## Product Change Notification / LIAL-09VUUA424

CCB 5151 Initial Notice: Qualification of a new lead frame DAP surface prep material for selected KSZ8041xx, SPNZ80105xx and KSZ8851xx device families available in 32L VQFN (5x5x0.9mm) package assembled at MTAI assembly site.

**CCB#: 5151**  
**Pre and Post Change Summary**  
**PCN #: LIAL-09VUUA424**

# Lead Frame Comparison

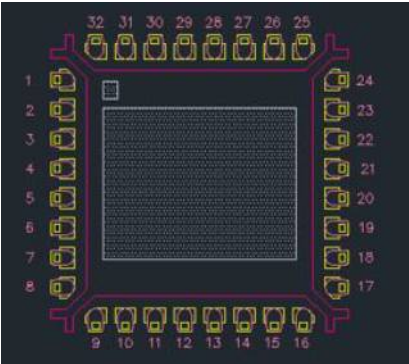
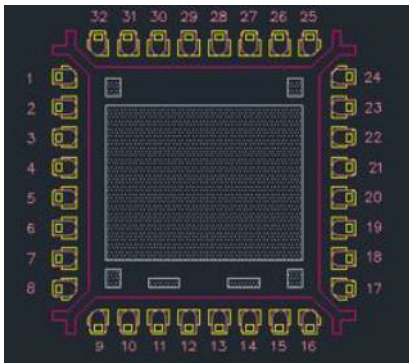
Pre Change	Post Change
 <p data-bbox="155 1270 717 1314">Lead frame DAP surface prep   Ag selective plating</p>	 <p data-bbox="919 1270 1481 1329">Lead frame DAP surface prep   Ag selective plating (Add more Ag area)</p>
